TOWN OF BERLIN PLANNING & ZONING DEPARTMENT - STAFF COMMENTS

APPLICATION: Site Plan Amendment

Deming Ridge (833 Deming Road)

AGENDA: November 19, 2020

SI	DEN	833 C
AWG	AWG	TD
cu.	1"=40"	
JU	NE 22, 2	020
-321 vo	3571-40	
	04 OF 09	
	GU

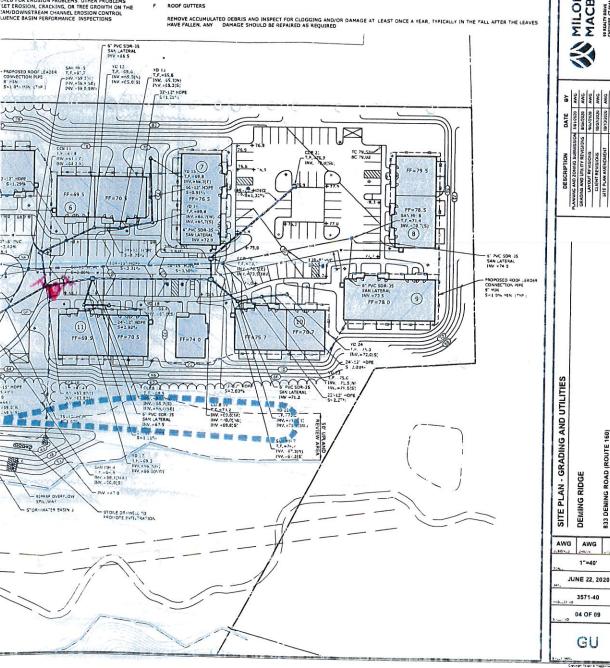
- 1) Apparently, sewer line from fitness building was not shown.
- 2) We will develop a DPA (Developer's Permit Agreement) to define materials and our expectations for ownership and operation of water/sewer system
- Plan should also show water/fire line service and meter locations on each of the buildings similar to Fieldstone Project

1) Clubhouse shows water service line but no sanitary lateral ((Sheet 04). Coordinate details with Berlin Water Control.

1) Add additional hydrant, as noted.
